RE: Tracking #: NRM2000358734
Response to NMOCD Denial of Closure
Wool Head 20 State Com 3 Battery

Incident #: NRM2000358734
Wool Head 20 State 3 Battery

Site Map
 (Revised 03/23/2020)
 Advance Energy Partners Hat Mesa
 NRM2000358734 - Wool Head 20 State Com #3 Battery

Figure 1: Example of 5-point sample grid for base composite sampling.

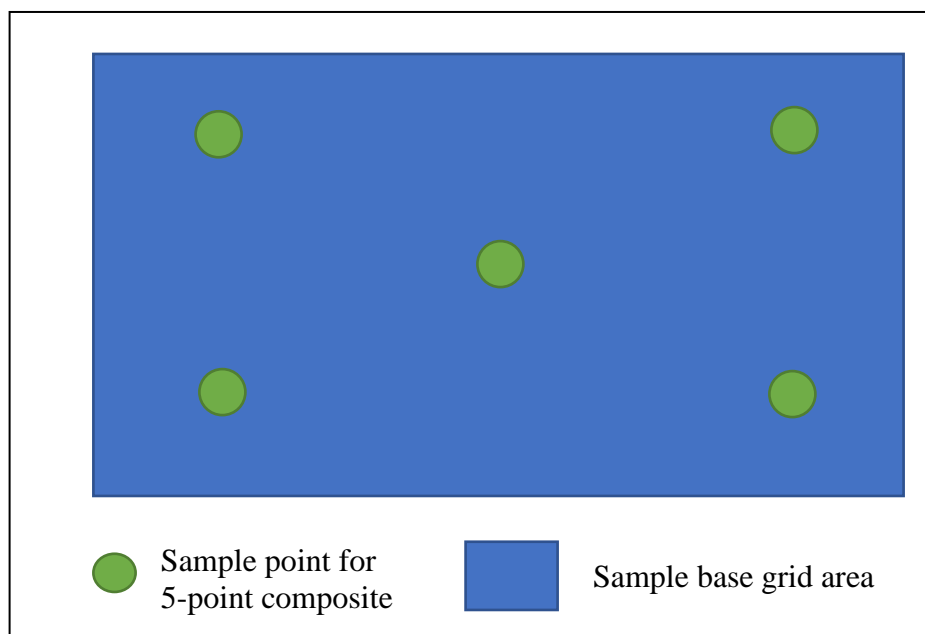
- *The report is missing a sampling diagram representing point(s) where samples were collected. It is unclear if the "ramp" samples are to be considered base samples or sidewall samples. If only 5 base samples were collected, more sampling will be needed to approve closure for this site.*

A 5-point composite base sample was collected from each sample grid for confirmation sampling. Five-point composite sample points were evenly spaced within each sample grid to obtain a representative sample of the area (Figure 1, below).
